**Statement of objection to LOT 1 PS 542433T P/Newham LOT 9LP 3017 P/Newham 1427
Rochford Road Newham Vic 3442**

**Siting of dwelling, outbuilding and access on a site that is covered by RCZ1, ES04 and
SL01 overlays.**

Submission 2
D20-104065

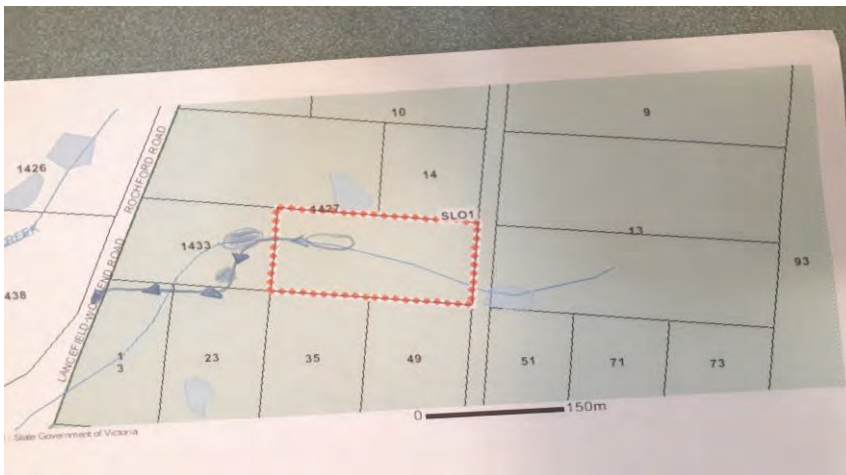
The proposed works will adversely affect the significance, character and appearance of the iconic Hanging Rock environs. Hanging Rock (HR) is the backdrop to this property and is a cultural icon. The building would be visible from the rock (even though The Design Response Statement in *Proposed use and development of a dwelling Report* says “the building will not be visible from the summit of Hanging Rock”) and detract from HR’s significance as a tourist site. See picture from Hanging Rock and site marked in orange. Picture 1.

Figure 1: Sag and sway distances

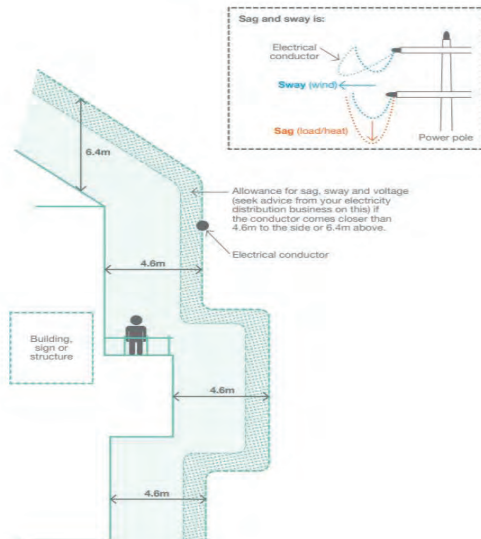
According to the rules from the Energy Safe Victoria website the distance from

a property must be no less than 4.6 metres. Thus the siting of the building near powerlines is in contravention of this regulation.
